ECE/TRANS/WP.29/GRSP/2009/18  
23 September 2009

Regulation No. 80  
(Strength of seats and their anchorages (buses))

Proposal for the 02 series of amendments to Regulation No. 80

Submitted by the expert from the European Commission \*/

1. Arrangements in the approval mark for a seat

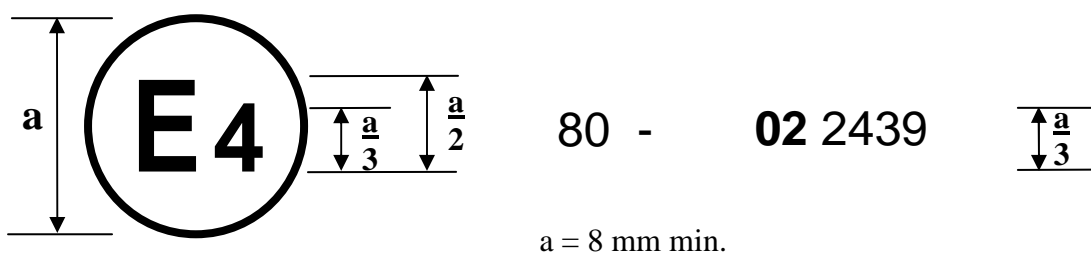
Annex 3, paragraphs 1. and 2., amend to read:

The above approval mark affixed to a seat shows that the seat type concerned has, with regard to the strength of the seats, the test being carried out in accordance with paragraph 2 of annex 4, been approved in the Netherlands (E4) under number 022439. The approval number indicates that the approval was granted in accordance with the requirements of Regulation No. 80 as amended by the 02 series of amendments.

2. Arrangements in the approval mark for a vehicle type

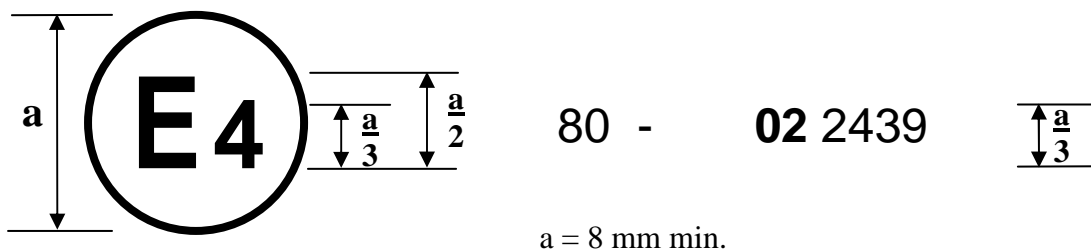
The above approval mark, affixed to a vehicle, shows that this type of vehicle has been approved in the Netherlands (E4) under number 022439 with regard to the strength of the anchorages on the vehicle. The approval number indicates that the approval was granted in accordance with the requirements of Regulation No. 80 as amended by the 02 series of amendments."
